## TECHNICAL BULLETIN

**505-18-12**

**MODEL AFFECTED:** 505

**SUBJECT:** NEW INTERIOR PROTECTIVE PADS,  
INTRODUCTION OF

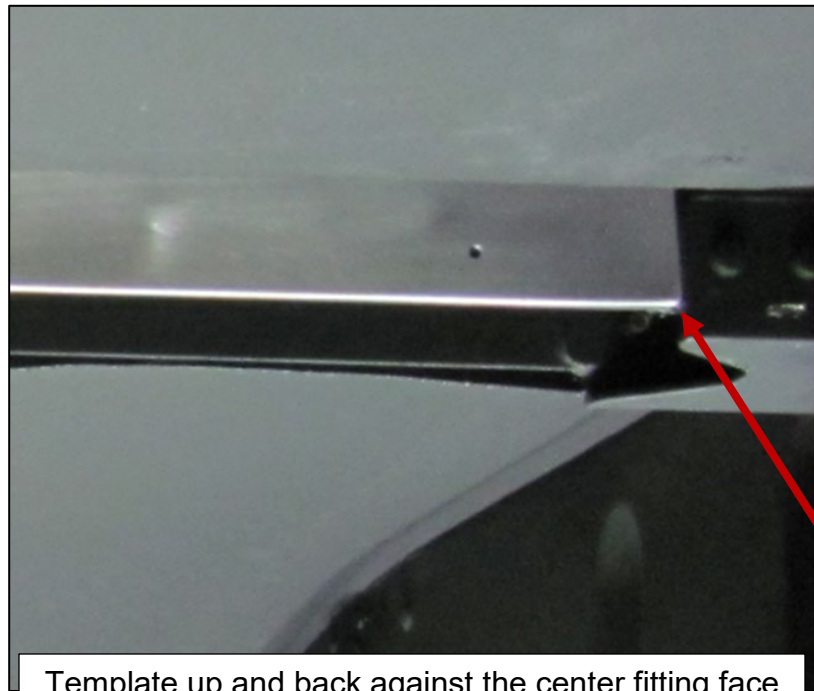
Prior to positioning the drill template SLS-704-001-005 and SLS-704-001-007 onto the cabin structure, ensure the pilot holes are in line with the snaps installed onto the pads (Figure 1).

kit, snap into position the additional short center interior replacement protective pad (Figure 1) as was selected from the **Required Materials** list.

**Figure 2** – Center Pad Template SLS-704-001-005 (Sheet 1 of 2)

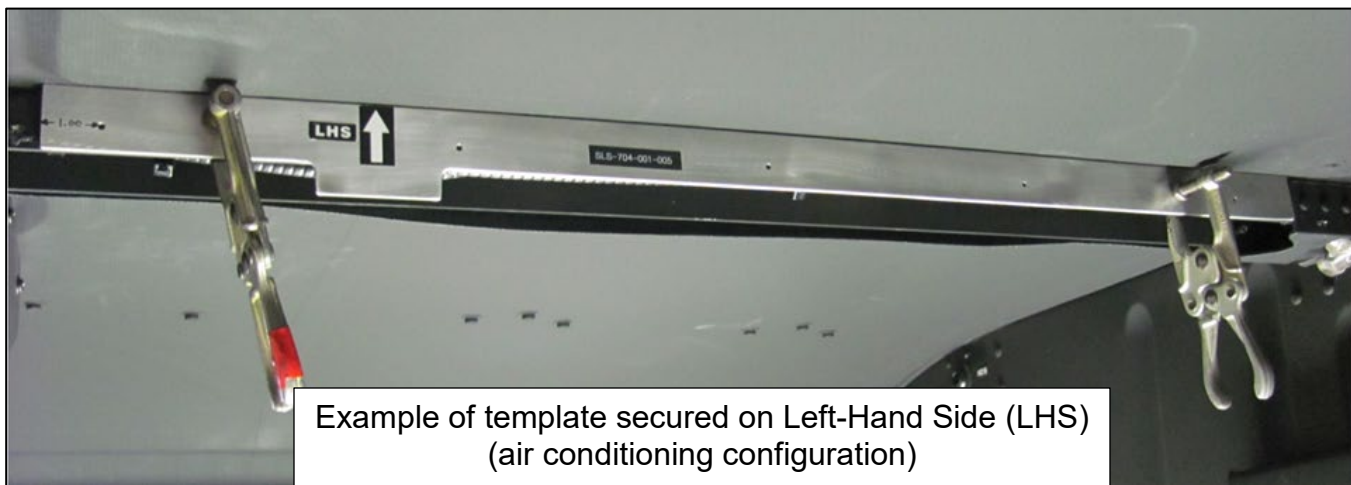
5. Locate drill template SLS-704-001-005 onto the cabin structure center left-hand side (LHS), (Figure 2, Sheet 1 of 2).
  - a. If equipped with Bell / Paravion Technology air conditioning kit PR-505AC-120M, cut off template end at 1 inch (25.4 mm) forward of the pilot hole as shown (Sheet 2 of 2).
6. Ensure the template is positioned aft against the center post fitting face and against the roof with LHS decal and arrow displayed upright (Sheet 1 of 2).

Template up and back against the center fitting face

Example of template secured on Left-Hand Side (LHS)  
(air conditioning configuration)

**Figure 2** – Center Pad Template SLS-704-001-005 (Sheet 2 of 2)

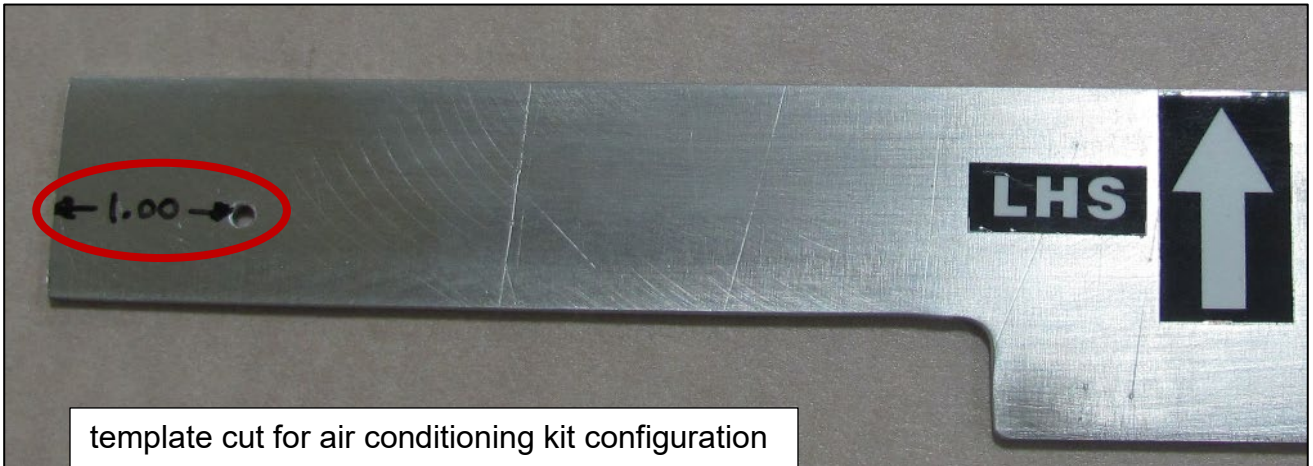
Cut template SLS-704-001-005, 1 inch (25.4 mm) forward of the pilot hole as shown. This is required only if the Bell / Paravion Technology air condition kit is installed. The following image shows the template once cut.

**Figure 3** - Template SLS-704-001-005 Right-Hand Side (RHS)

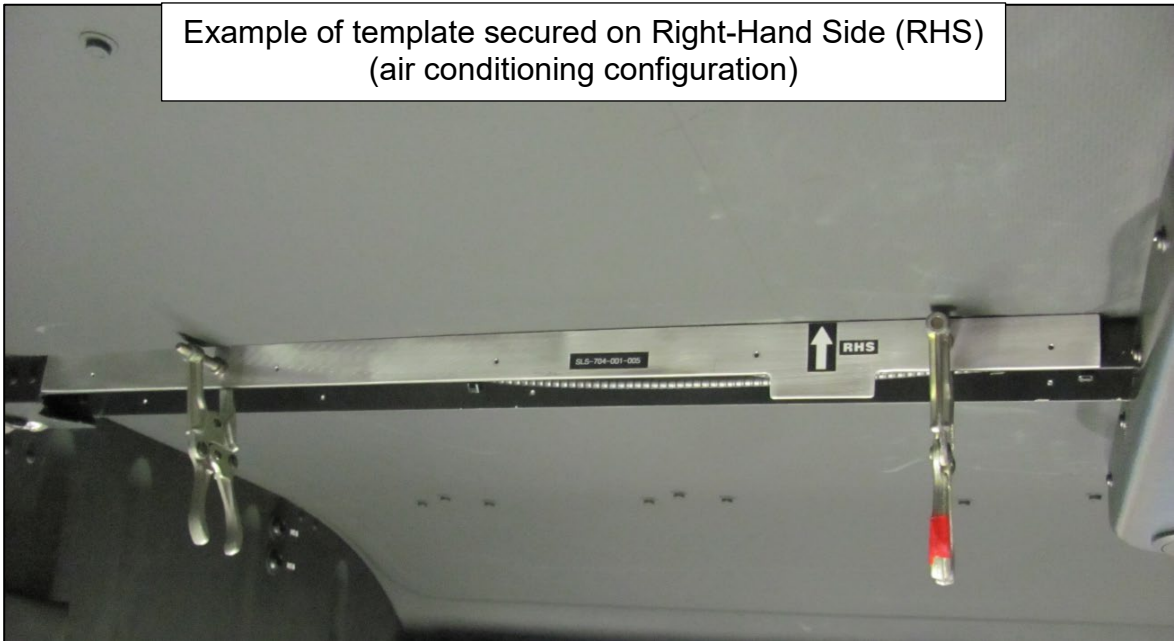
7. Match drill the pilot holes from the template into the cabin center post flange.
8. Repeat steps 5 through 7 for the center cabin post right-hand side (RHS) (Figure 3), with the exception to ensure the template is positioned aft against the center post fitting face and against the roof with **RHS** decal and arrow displayed upright.
9. Locate drill template SLS-704-001-007 onto the right-hand side (RHS) cabin longeron (Figure 4).
10. Ensure the template is positioned aft against the bulkhead clip face and mate against the longeron contour (Figure 4).

Example of template secured on Right-Hand Side (RHS)  
(air conditioning configuration)

**Figure 4** - Longeron Pad Template SLS-704-001-007

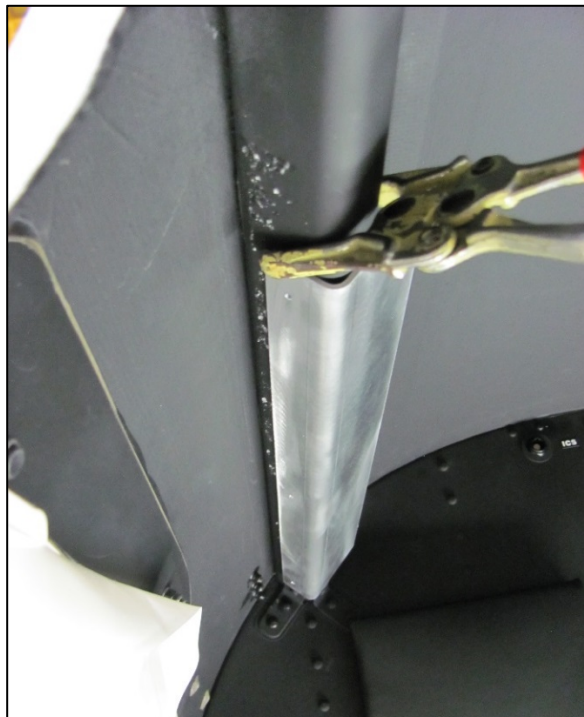
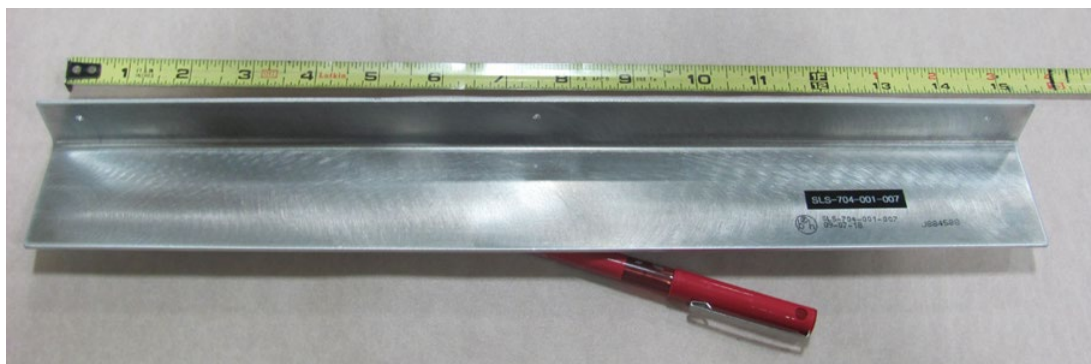
11. Match drill the pilot holes into the cabin longeron. Three pilot holes are required.
12. Repeat steps 9 through 11 for the side cabin longeron left-hand side (LHS).

Template SLS-704-001-007 secured on RHS

Template RHS looking outboard from inside the cabin aft against the bulkhead clip face.

**Figure 5 - Longeron Pad Installation**

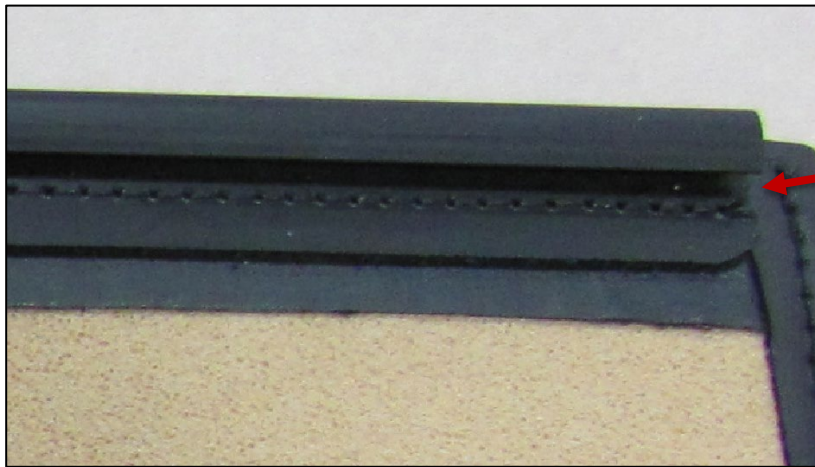
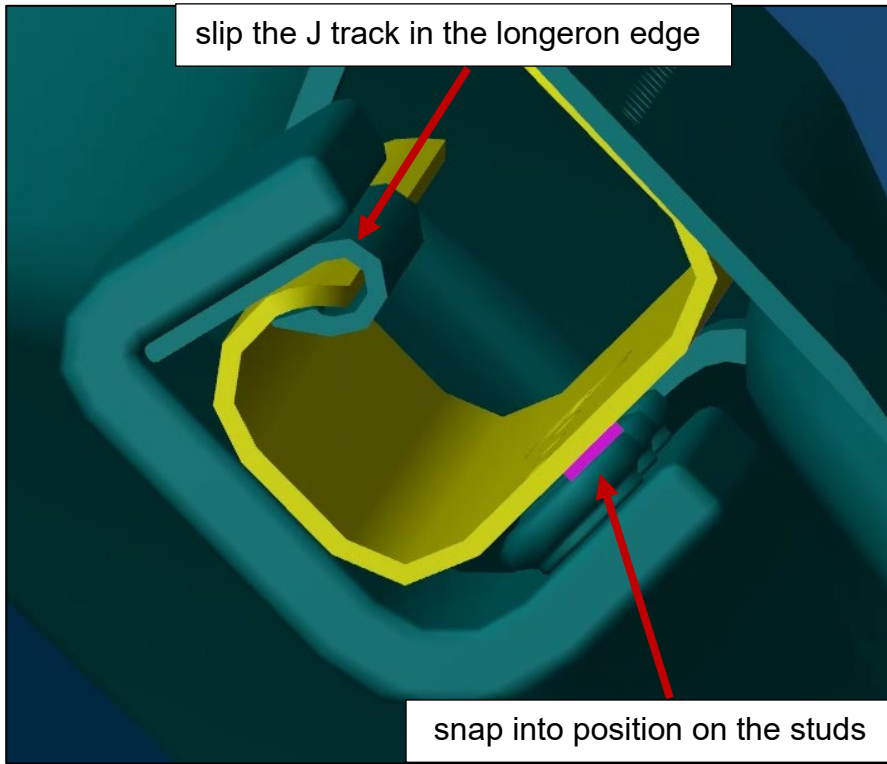
17. Install the longeron RHS and LHS replacement protective pads as was selected from the **Required Materials** list. To install, slip in position the pad's J track onto the longeron edge then snap into position on the studs (Figure 5).
18. Make an entry in the helicopter logbook and historical service records indicating compliance with this Technical Bulletin.
